# **HILLWOOD SUBDIVISION, RESUBDIVISION OF**

## **LOT 1**

APPLICATION NUMBER 5 DATE October 6, 2005

REQUEST Subdivision

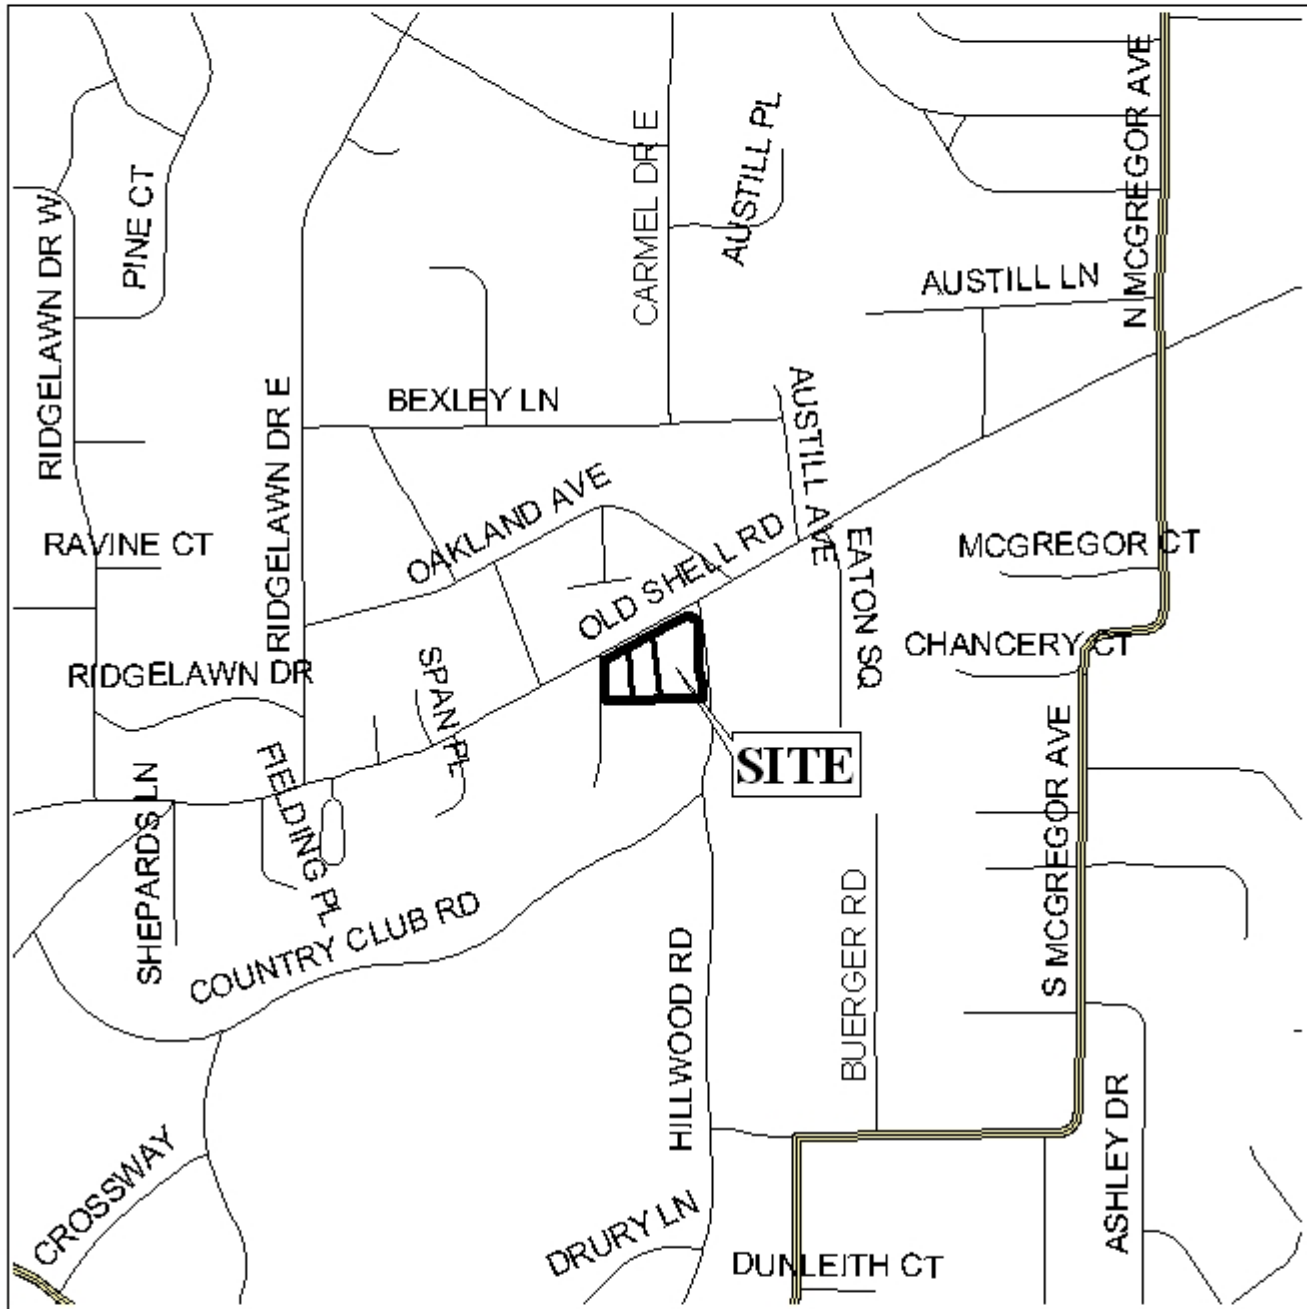
The site fronts Old Shell Road, which has a 60' right-of-way and Hillwood Drive, which has a 50' right-of-way. Additionally, Lot C is denied access to Springhill Trace located to the West of the site because it is a substandard private road.

As indicated on the plat, part of an existing structure crosses the lot line between Lots A and B. Therefore, removal of the structure must be accomplished prior to the recording of the final plat so as not to create a violation of the Zoning Ordinance, as shown on the plat.

The plat meets the minimum requirements of the Subdivision Regulations and is recommended for Tentative Approval subject to the following conditions: 1) Lot C is denied access to Springhill Trace; 2) the removal of an existing structure prior to the recording of the final plat; and 3) full compliance with Engineering comments (*Stormwater detention is required for this site. Common area for detention should be shown on the preliminary plat. Must comply with all stormwater and flood control ordinances. Any work performed in the right-of-way will require a right-of-way permit.*)
